Addendum Number: 03

Owner: Robinson-Palestine Water Commission

Project Name: Water Treatment Plant and Campus

Project Number: 0210007.00

FOUNDATION DETAILS - WTP

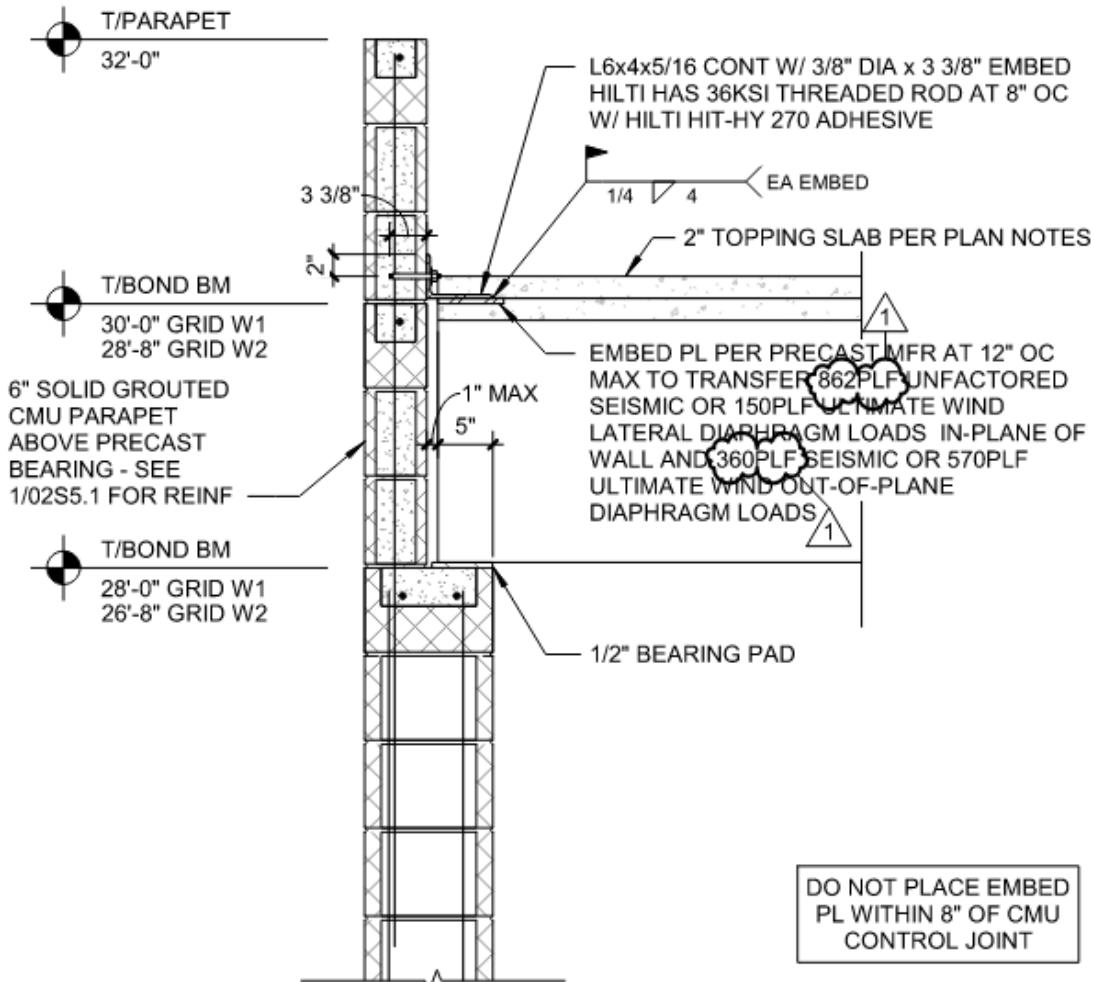
1. Detail 3 on Sheet 02S5.2 shows the double tee precast sitting partially on a 12" CMU bond beam with a 6" CMU parapet. However, this does not align with the general design of this wall as shown in Detail 1 on Sheet 02S3.1. I assume that the precast will simply extend past the 12" CMU and connect to the 4" CMU veneer. Am I correct in this assumption or am I overlooking something?

FURNITURE PLAN GENERAL NOTES

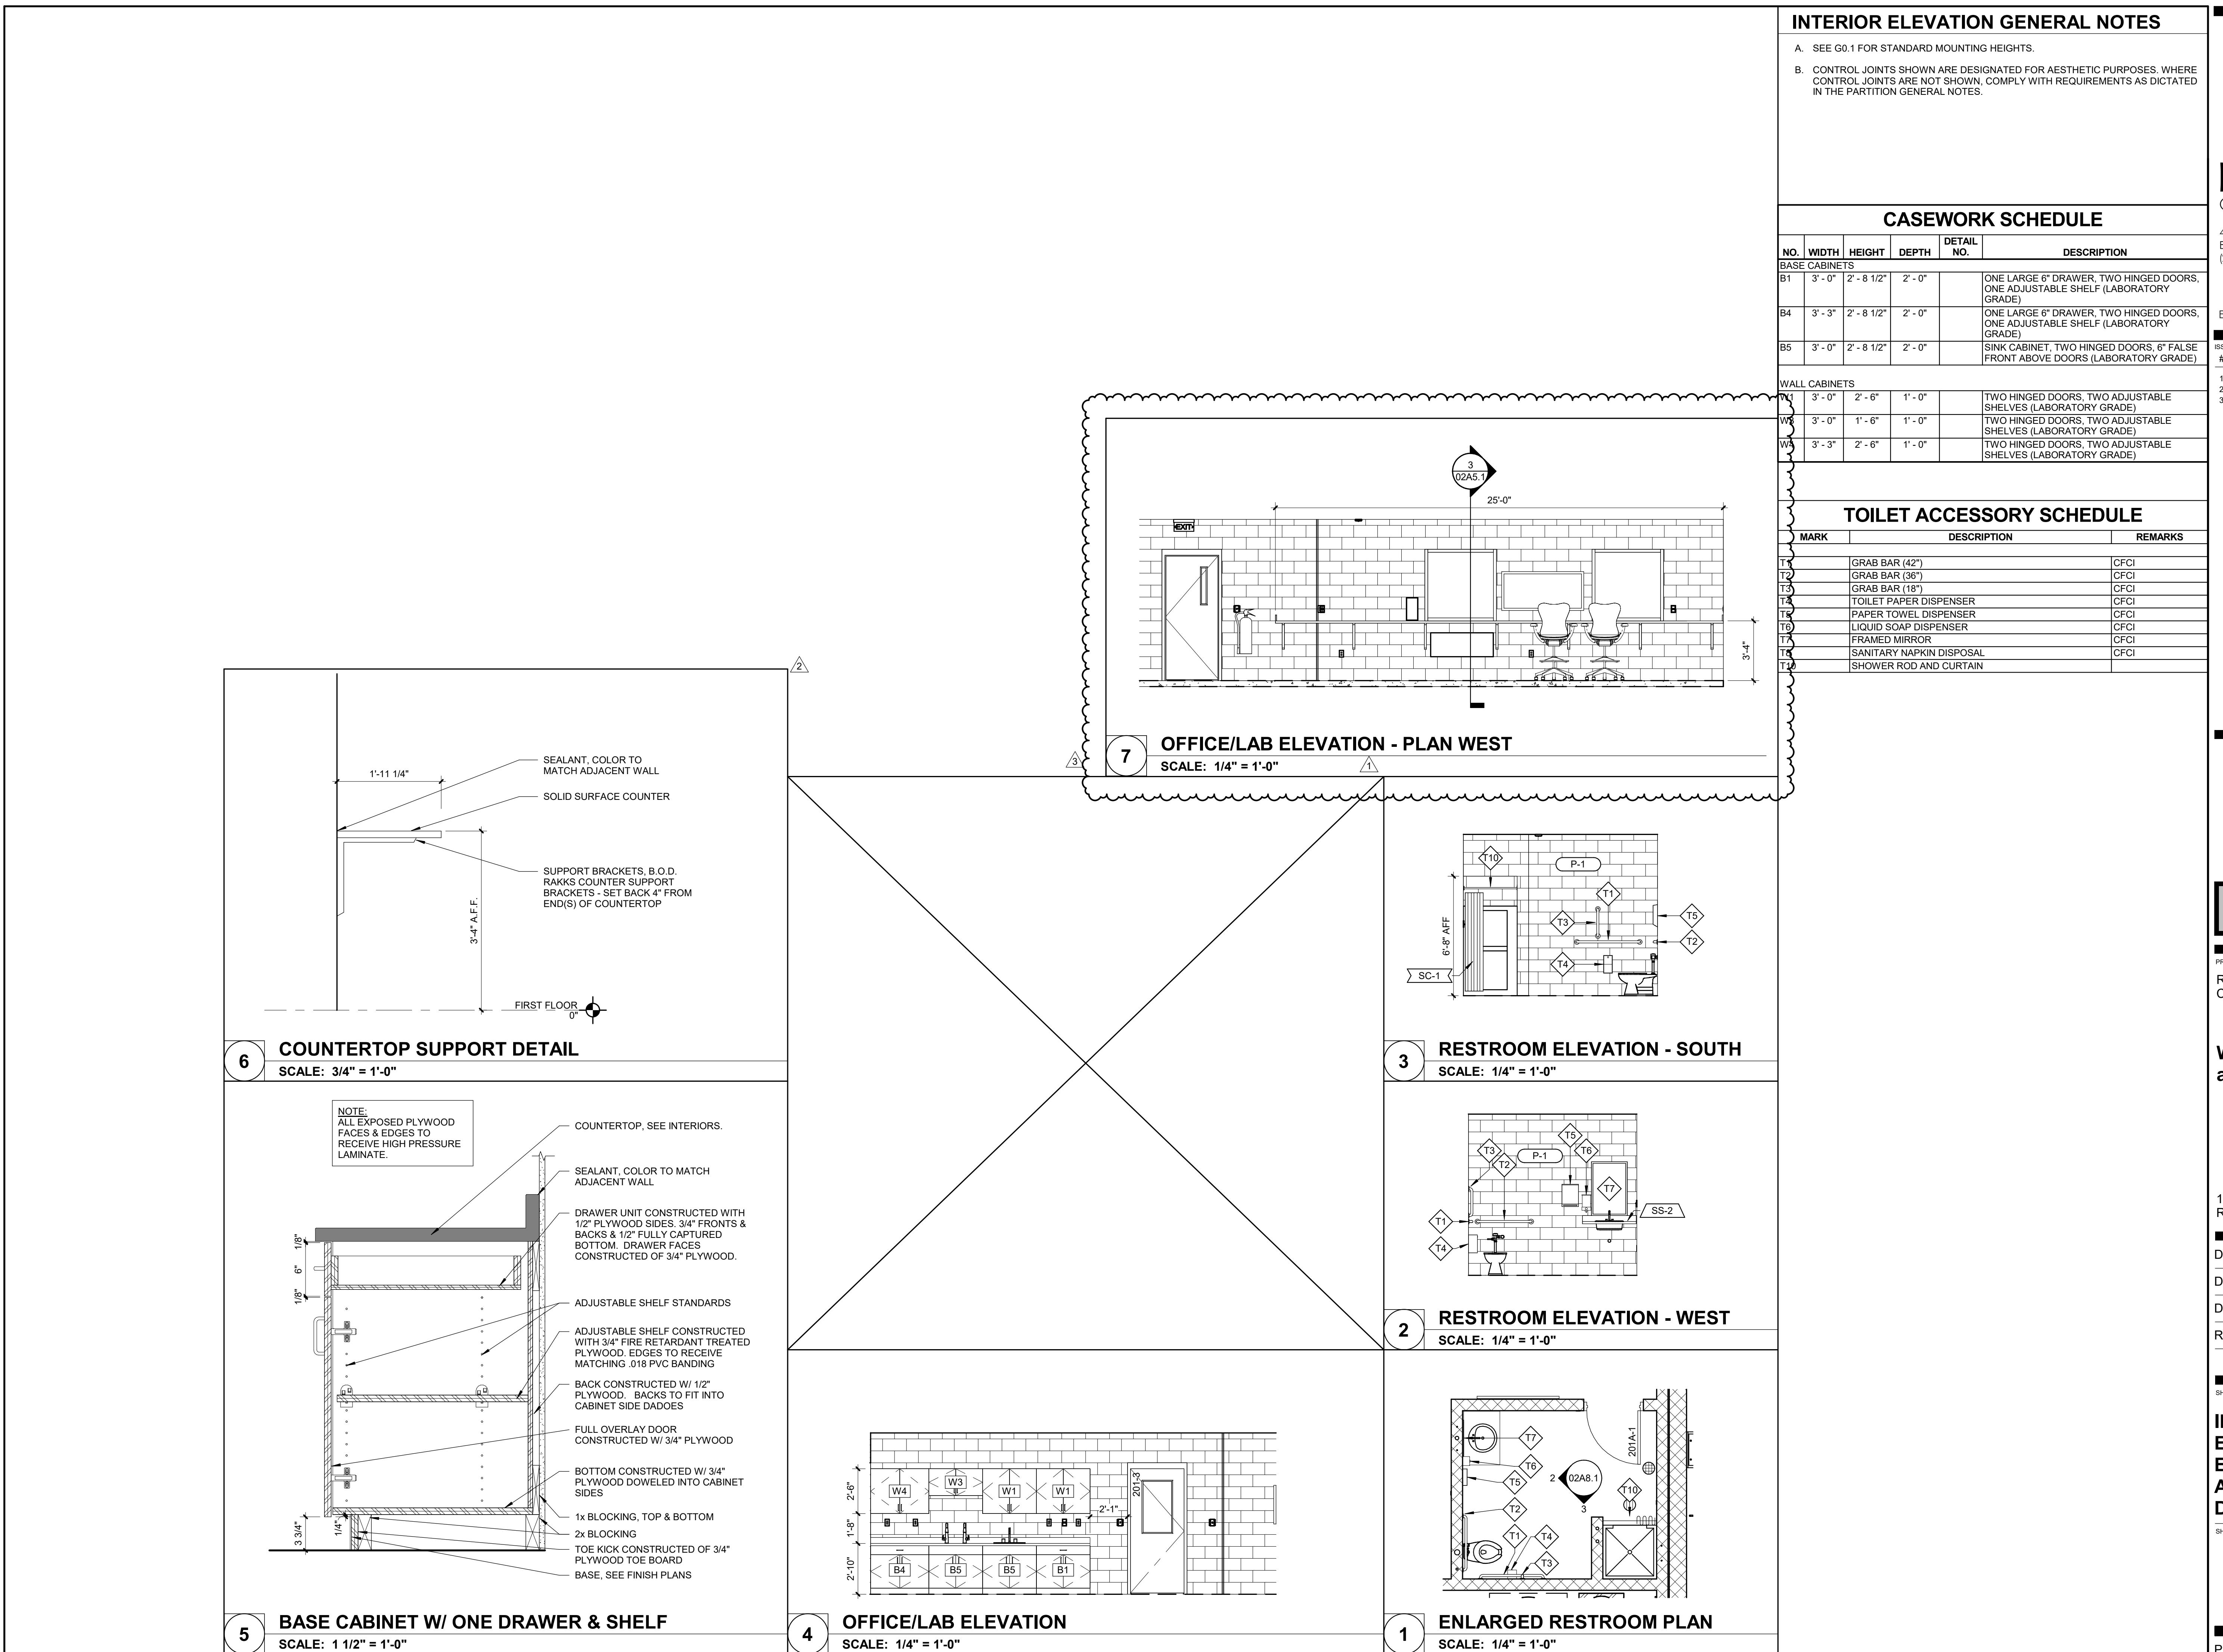
RFC #2: Note A on drawing GI5.0 says that the contractor is to procure all furniture. Note K. on drawing 01A1.1 says that furniture is shown for reference only and is not in contract. Please clarify.

- 01A1.1 – FLOOR PLAN – O/M
 - REVISE Plan General Note K to be, "CONTRACTOR TO PROCURE ALL FURNITURE. SEE GI5.0 FOR FURNITURE INFORMATION."
- 02A1.1 – FLOOR PLAN – WTP
 - ADD Elevation marker for detail #7 in OFFICE AND LAB 201
- 02A8.1 – INTERIOR ELEVATIONS, ENLARGED PLANS, AND WINDOW DETAILS
 - ADD detail #7, OFFICE/LAB ELEVATION – PLAN WEST, as shown.
- GI5.0 – FURNITURE SCHEDULES
 - ADD Overall Size column to Furniture Schedule, as shown.
- GE5.1 – ELECTRICAL SITE SCHEDULES
 - ADD luminaire type M to luminaire schedule. See attached sheets.
- 1E1.2 – OFFICE BUILDING LIGHTING PLAN
 - ADD keynotes #4, 5, and 6. See attached sheets.

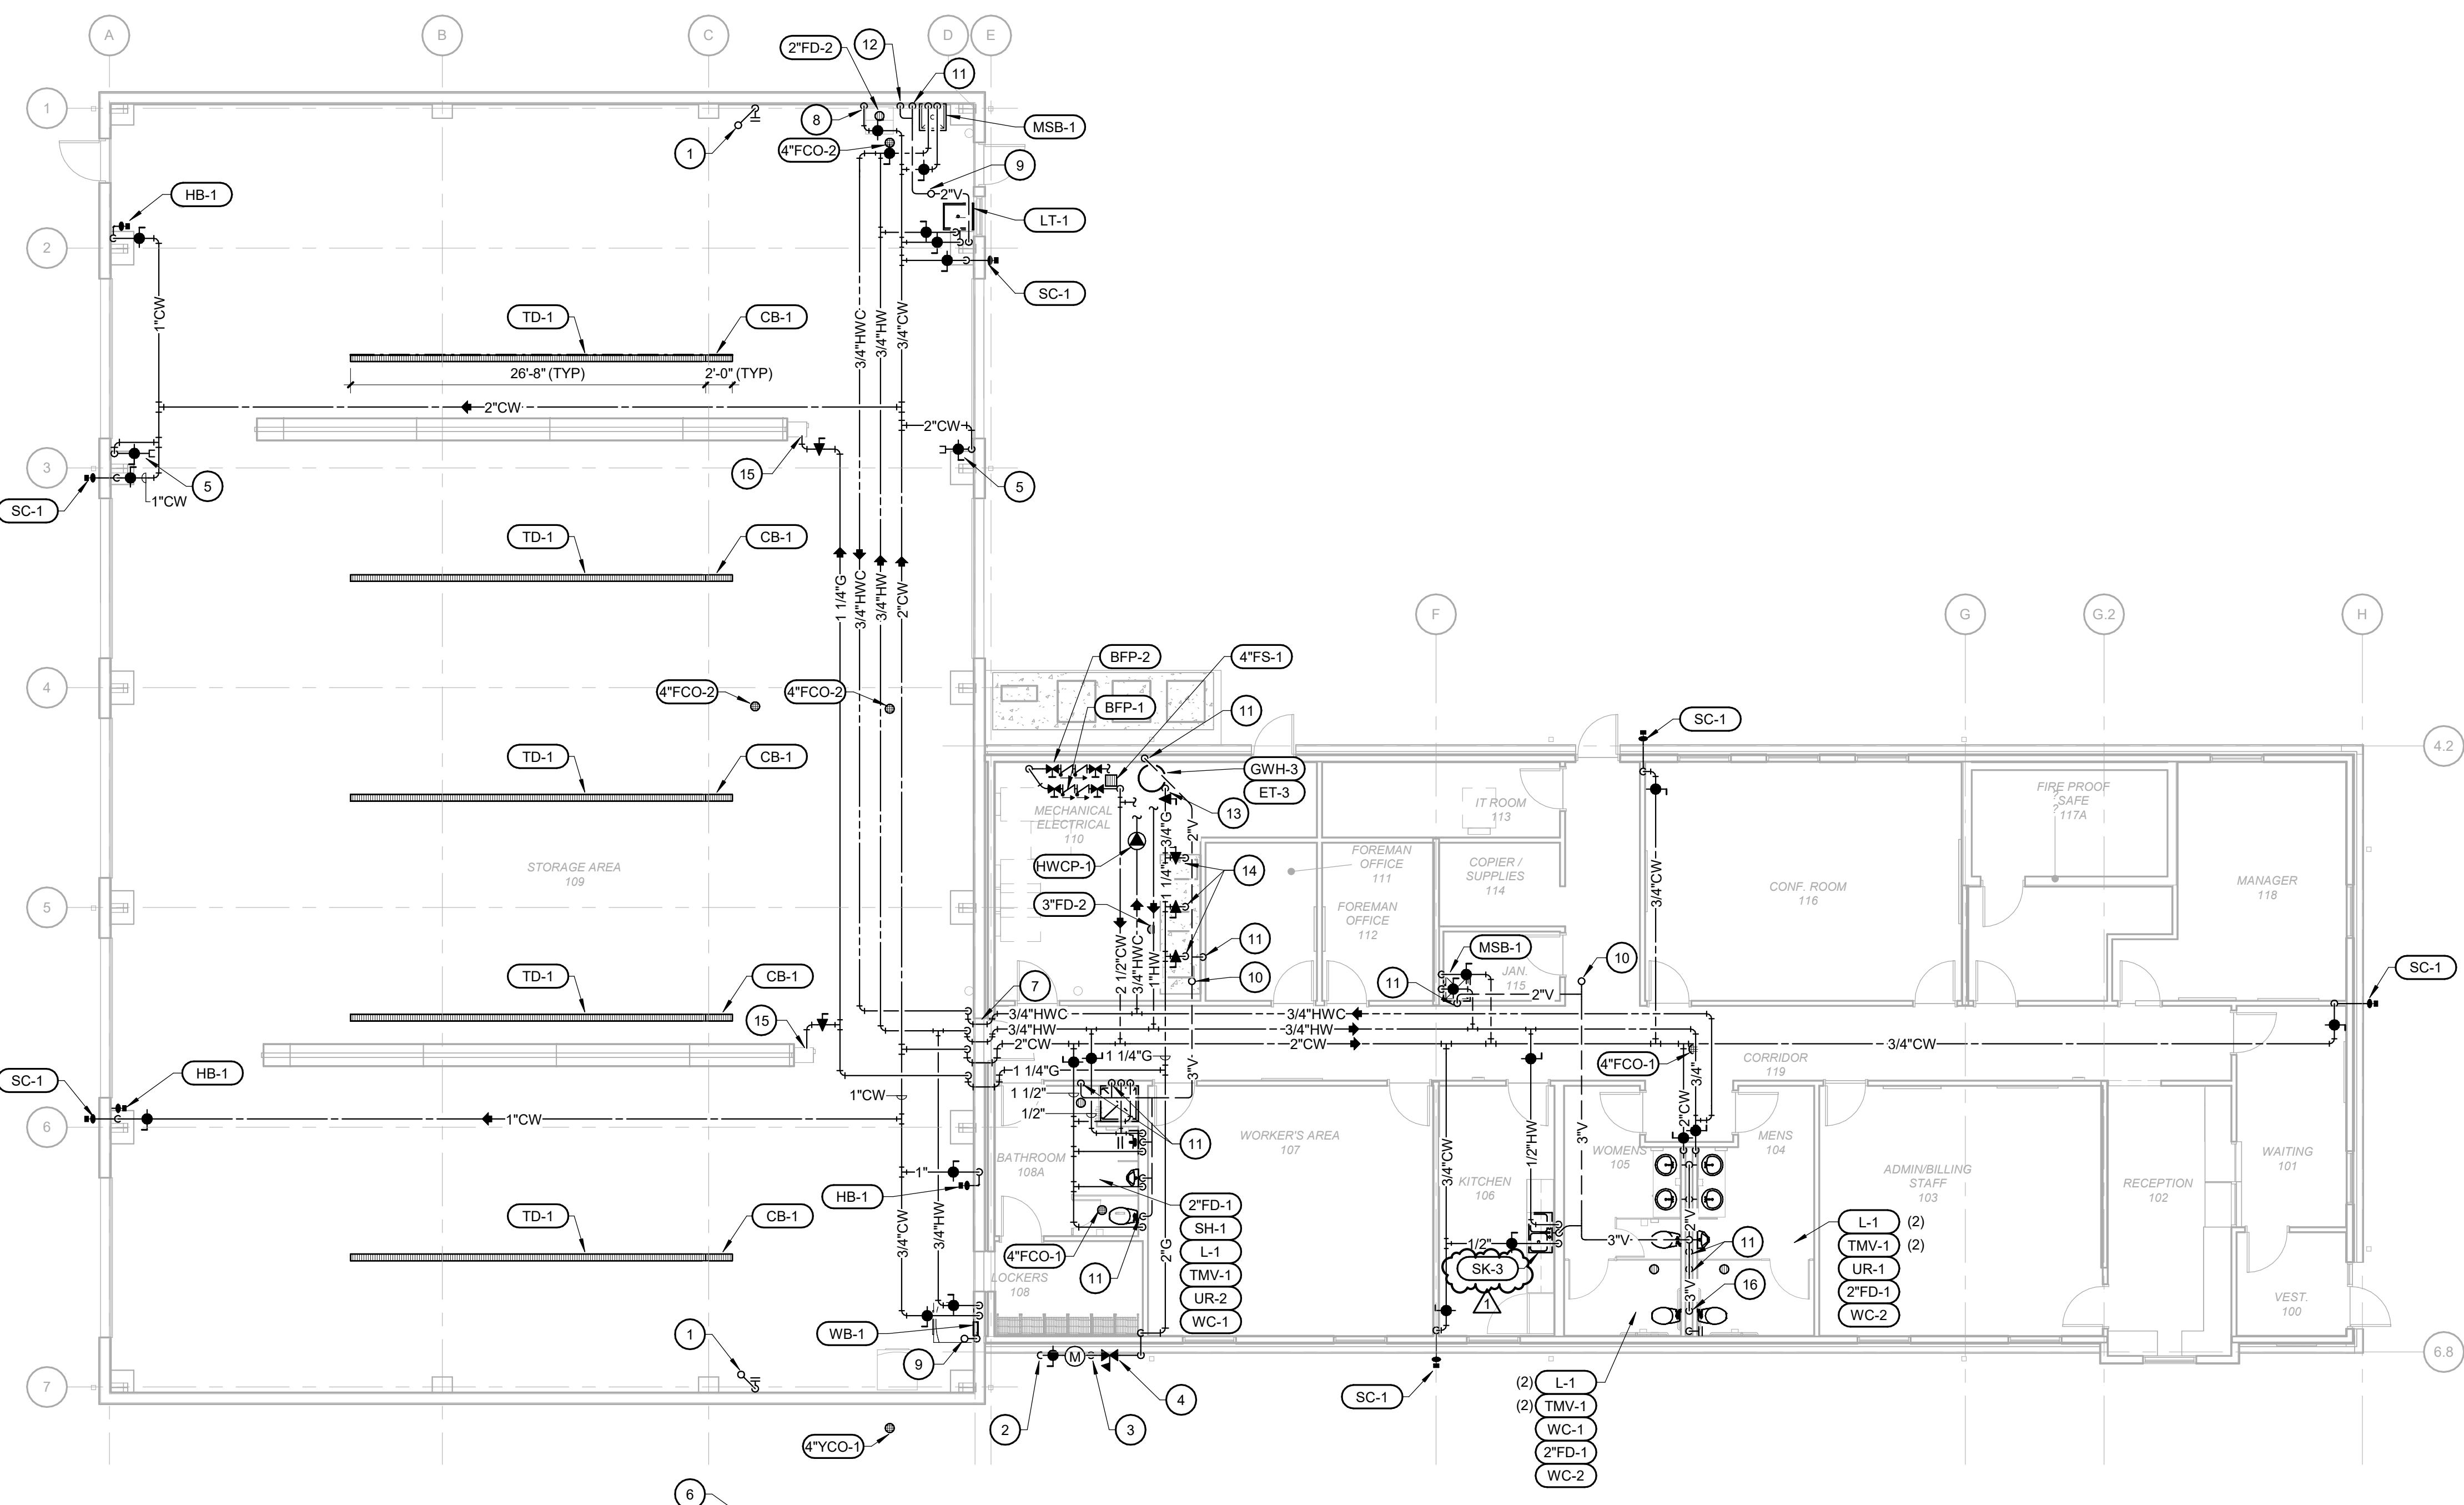
- 1P1.1 – FIRST FLOOR PLUMBING PLAN – O/M
 - REVISE Kitchen sink designation to "SK-3."
- GP6.1 – SCHEDULES
 - ADD description for SK-3 to plumbing fixture schedule.
